NETWORK RAIL (HUDDERSFIELD TO WESTTOWN (DEWSBURY) IMPROVEMENTS) ORDER

Calder Road – Design Refinement

Document Reference	151667-TSA-00-TRU-CNT-W-LP-000318
Author	Network Rail
Date	08 November 2021

Figure 1: Flyover Structure, structural optimisation view looking west through structure

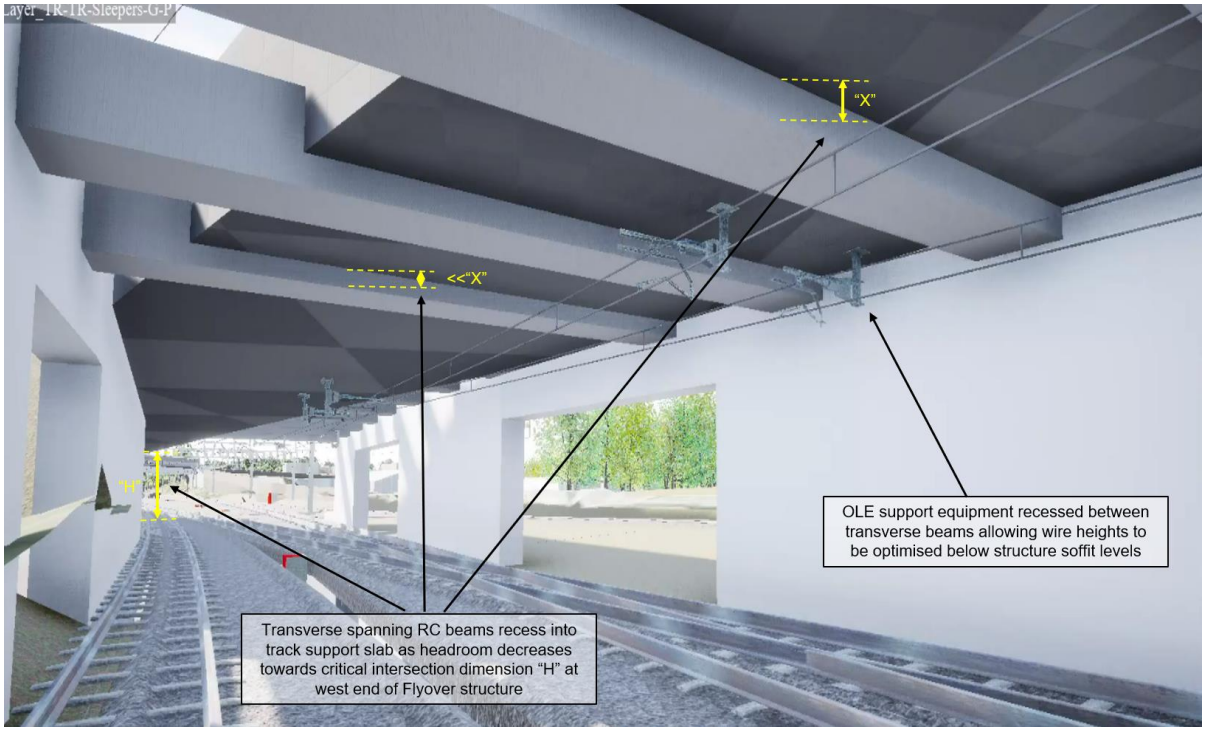
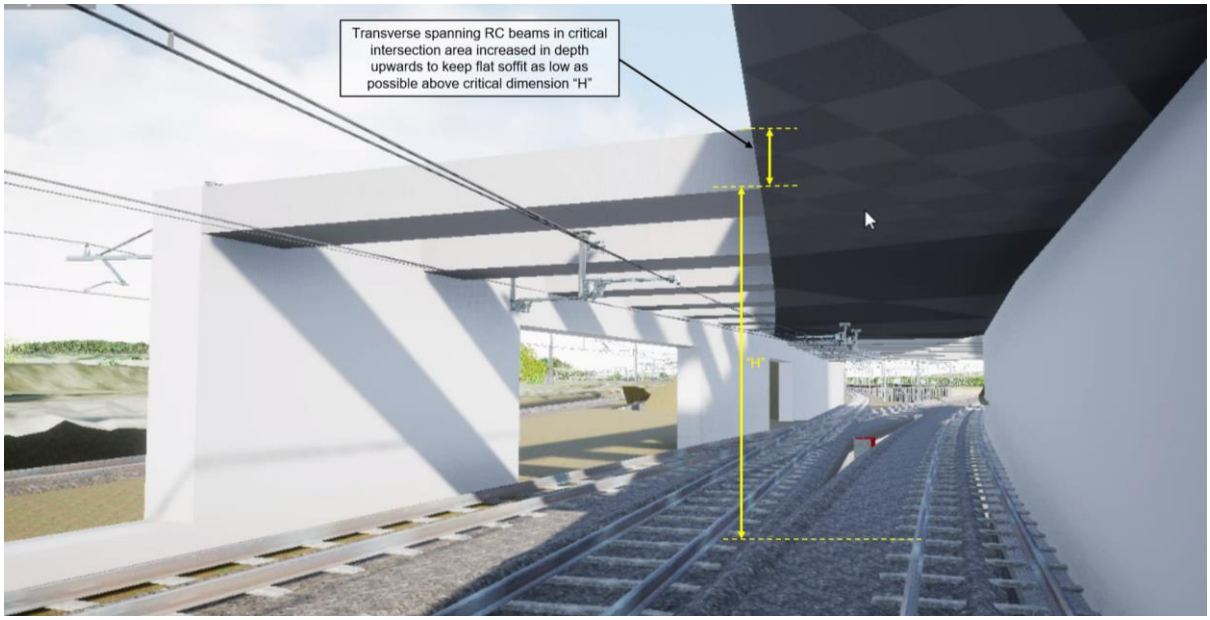
3.3.1 Since the submission of the Order, the structural design has been further optimised as part of the GRIP4 design development. This is illustrated in the visualisations in Figure 1 and Figure 2.

Figure 3: Calder Road Overbridge, structural optimisation looking east through structure

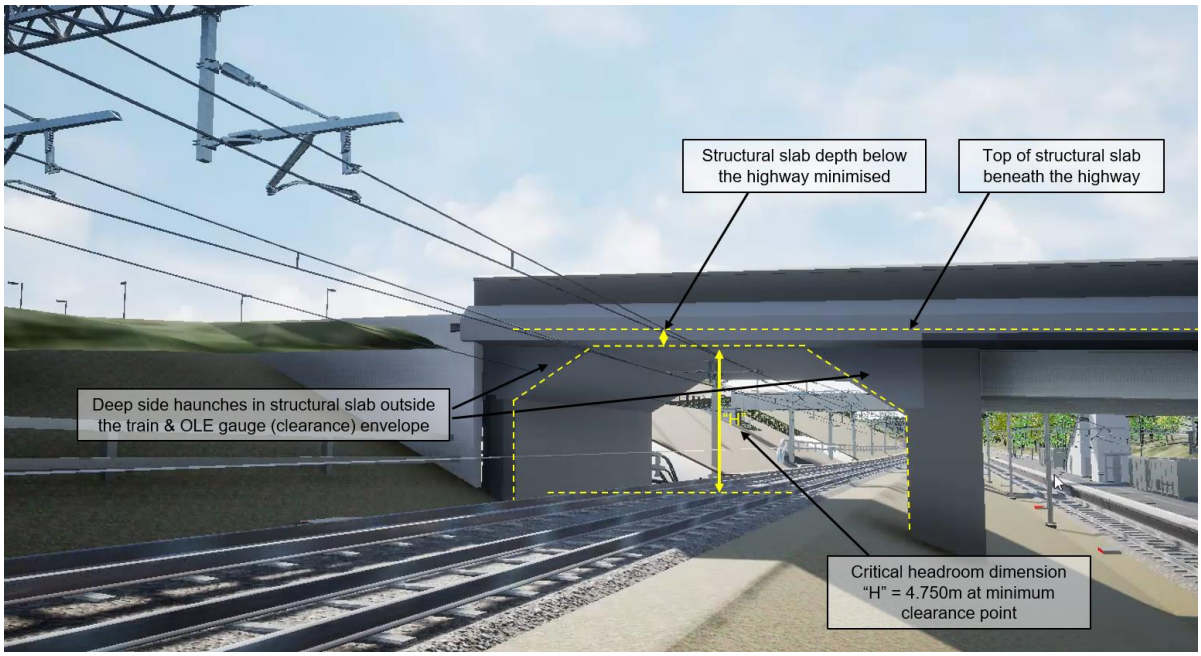
3.7.1 At GRIP4, a further design refinement has been made to the fast line span. This has involved reducing the effective overall span by the addition of deep side haunches and re-positioning of large high voltage (HV) utility sleeves to the outer

edges of the structure. In total the above refinements have reduced the effective structural depth above the minimum clearance point by approximately 0.3m (300mm). This is illustrated in the visualisation below:

Figure 4: Retaining Wall indicative layout

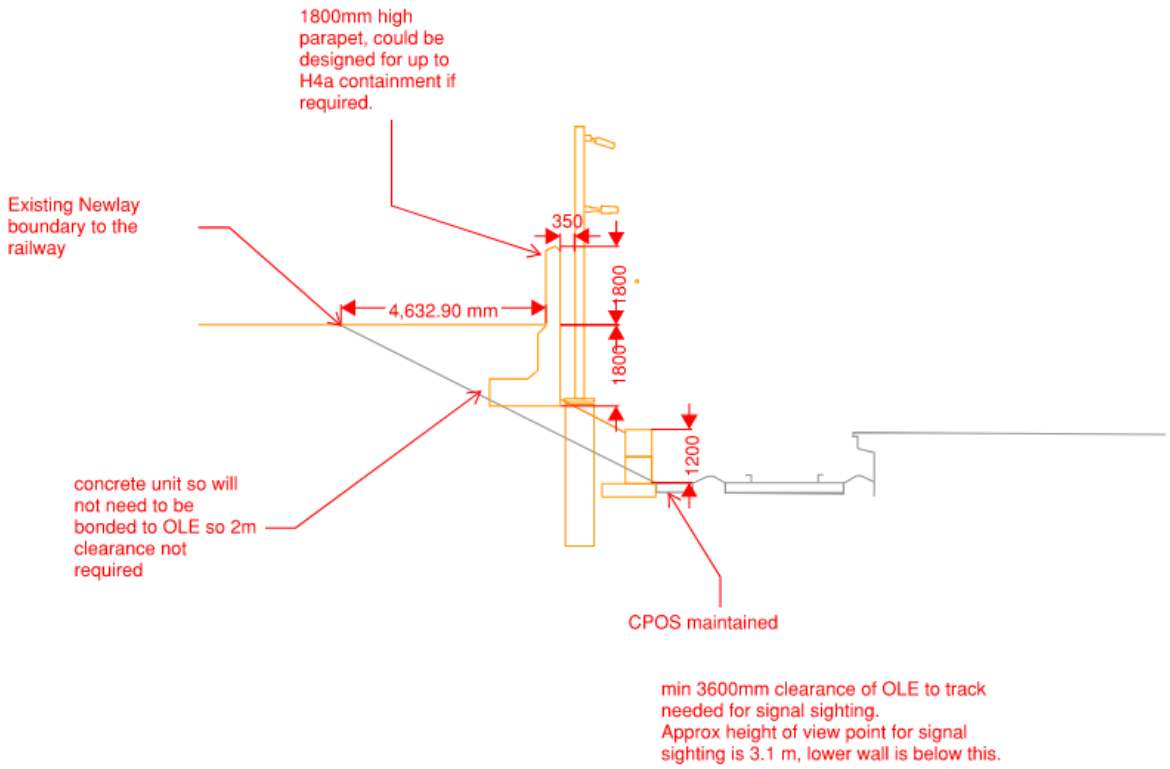
4.2.1 An opportunity to provide an additional retaining wall parallel to the railway is being explored on the north side of the railway (to the south of the Newlay Readymix site area). This would enable an opportunity to move the railway boundary south which would in-turn mean that a section of land that is currently within the existing Network Rail boundary could be provided to form part of the Newlay Readymix site. The location of the wall is highlighted on the drawing in Appendix B and a proposed section is shown indicatively in Figure 4. The retaining wall and area created by the retaining wall are within the LoD of Work No. 15.

Project: Transpennine Route Upgrade
Contract No.: 151667
Contract Title: West of Leeds
Drawing Title: Planning Drawing Proposed Calder Road Highway Alignment

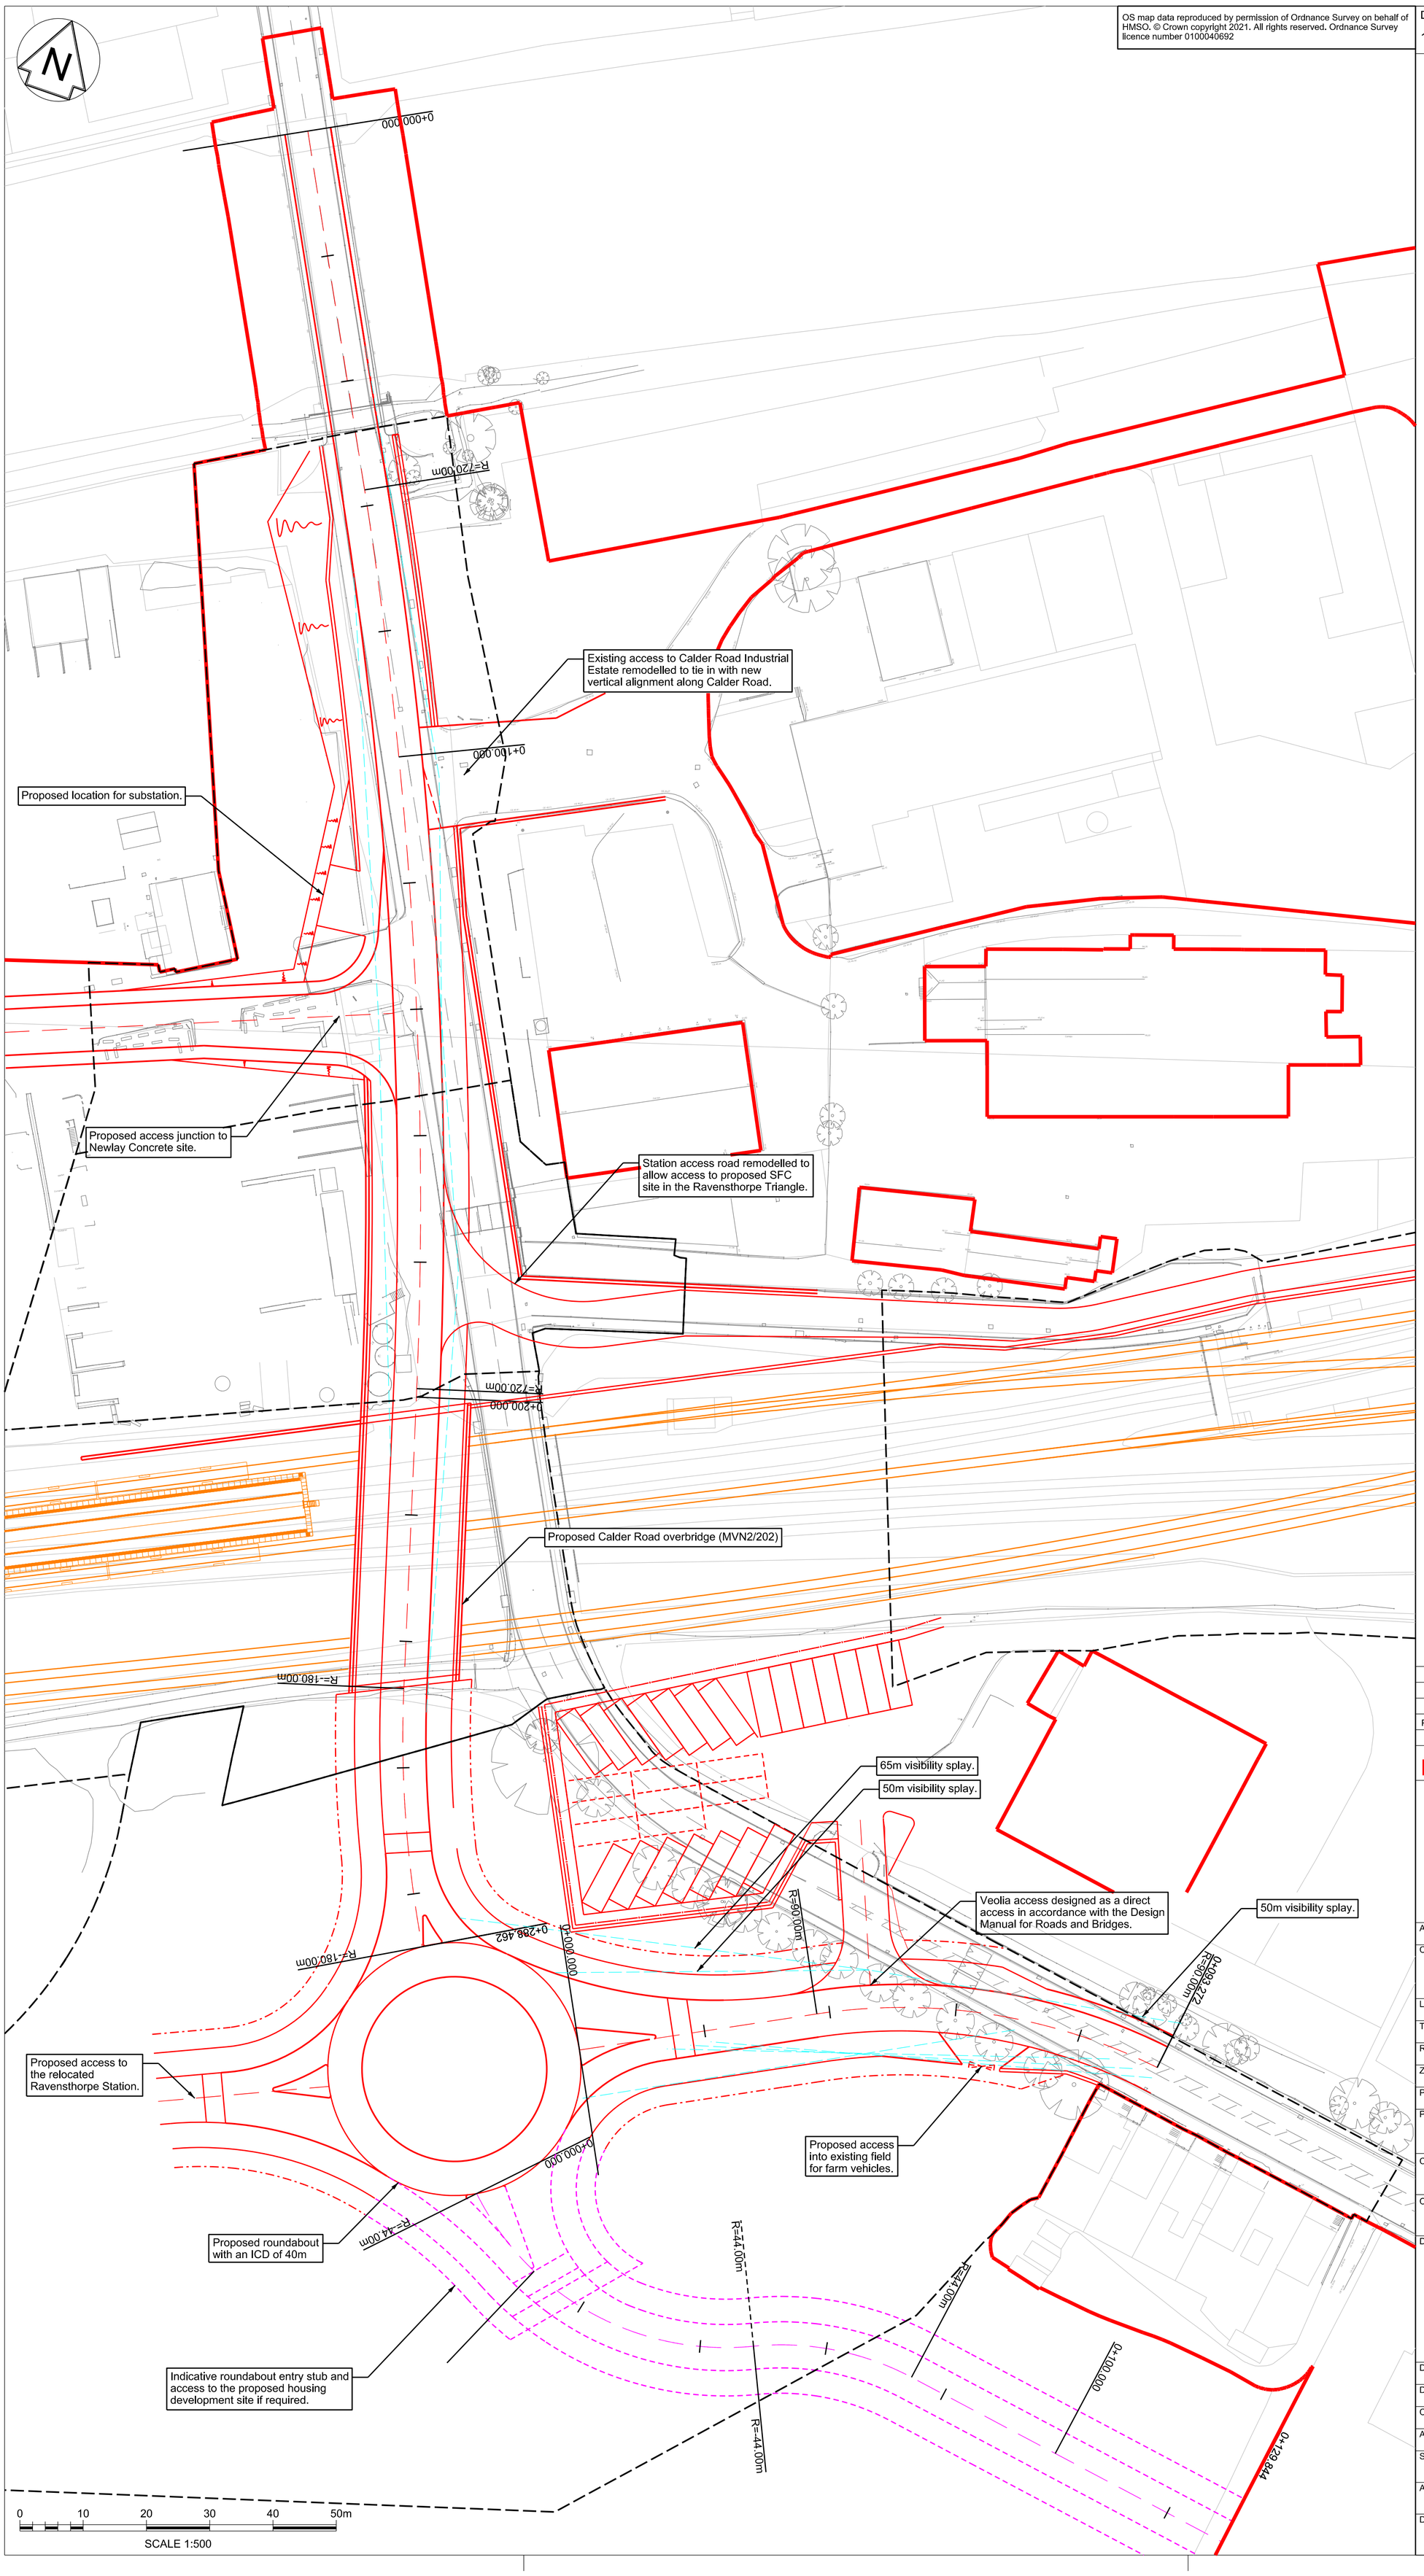
4.1.1 The proposed design refinement is provided in Appendix B. The key changes to this relative to the Order scheme are:

- The refinement of the railway vertical geometry and reduction in the structural depth of the Calder Road overbridge described in Section 3.
- This enables the proposed Calder Road bridge and associated highway to be located further east and closer to the existing Calder Road bridge due to the lower bridge level required.
- While a roundabout is still proposed, this would be relocated 45m to the east of the location shown in the Order.

4.1.2 Like the Order, the design of the Calder Road highway realignment and roundabout has been undertaken in accordance with the DMRB. However, the proposed refined design includes the following changes:

- A reduction in the carriageway superelevation from 5% to 2.5% over the bridge to suit the revised horizontal highway geometry.
- The removal of the separated footway/cycleway on the northeast side of the bridge. This is replaced with a footway/cycleway which follows the vertical alignment of the main carriageway.
- The provision of sufficient width to cater for both pedestrians and cyclists on the highway and at the roundabout. The exact form of this will be discussed and agreed with Kirklees Council.
